STANDARD FIELD SERVICE BULLETIN

FSB Number	CHRAEFSB2016-2
Author	Tony Bryan
Date	01/04/2016
Subject	Moto X Play, Droid Maxx 2 - Device Not Charging
Model Affected	XT1562, XT1563, XT1564, XT1565
Level Of Repairs	Level 2

NFC Flex (Service P/N: 24014144002)

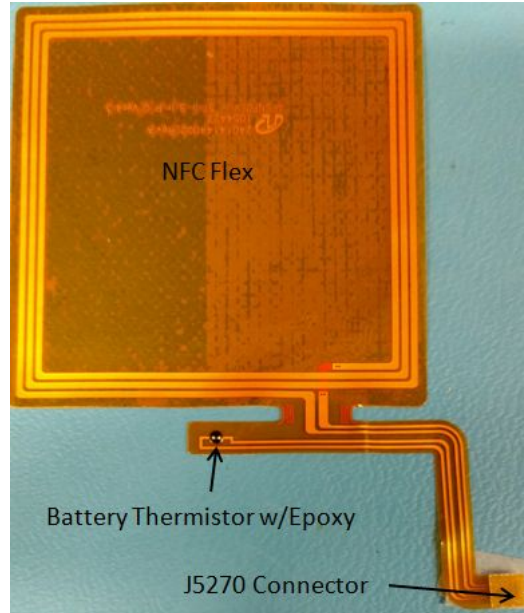
Motorola is aware of a potential field return issue on the Moto X Play (ROW) & Droid Maxx 2 (VZW) products related to Battery Charging. Some users reported that although their device detects Charger is connected, the actual charge percentage in the Battery Meter never increases. Engineering analysis of these devices determined that the Battery Thermistor was damaged (cracked) from excessive mechanical stress (likely from drop impact in the field). The damaged Battery Thermistor results in erroneous battery temperature readings which disable charging.

Motorola added underfill epoxy over the Battery Thermistor component located on the NFC Flex (Service P/N: 24014144002) to protect the component from damage during drop impacts. Motorola is currently working with supplier, and providing additional limit samples, to help better to control the epoxy application process. See image below.

Example: CQATest.Apk Battery Info Screen - **Bad** Reading (Left) vs. **Good** Reading (Right)

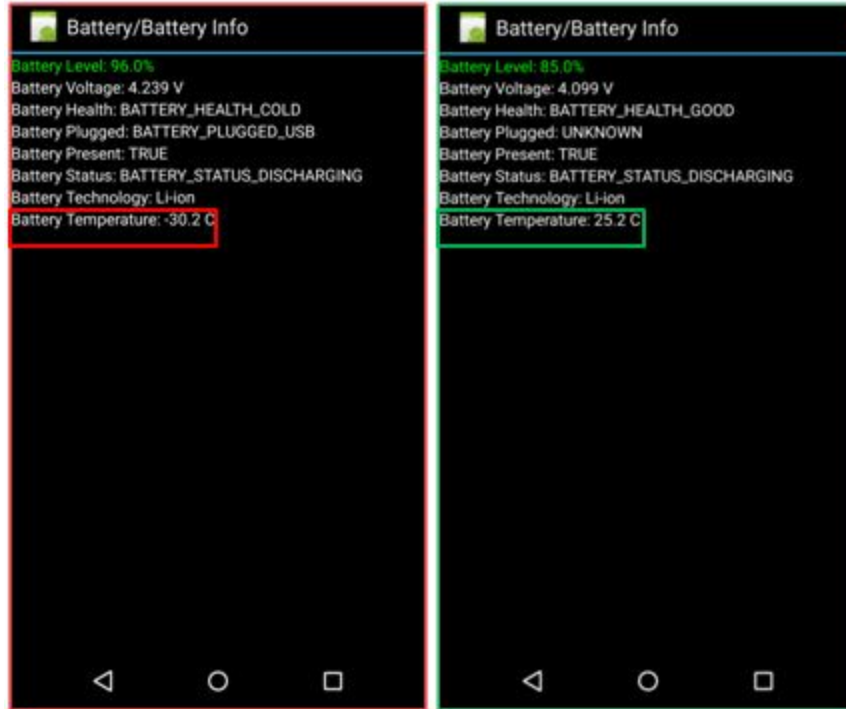
1. Confirm the customer complaint by testing “Charging” functionality using approved testing procedures. If confirmed:
2. Launch CQATest.Apk and execute Battery Info test to read Battery Temperature.

- a. If the Battery Temperature reading is normal (typically positive 25 to 30 degrees celsius) , then this bulletin does not apply. Follow normal repair process to determine the problem.

- b. If the Battery Temperature reading is abnormal (damaged component typical read **negative** 30 to 35 degrees celsius), then continue to Step 3.
3. Disconnect/Reconnect the NFC Connector (J5270) to ensure it is properly mated then repeat Step 2 above.

- a. If the Battery Temperature reading is still abnormal, then replace NFC Flex (Service P/N: 24014144002).
4. Per Service Manual, carefully reassemble the device and completely retest the device, per standard Service procedure, to ensure proper repair.
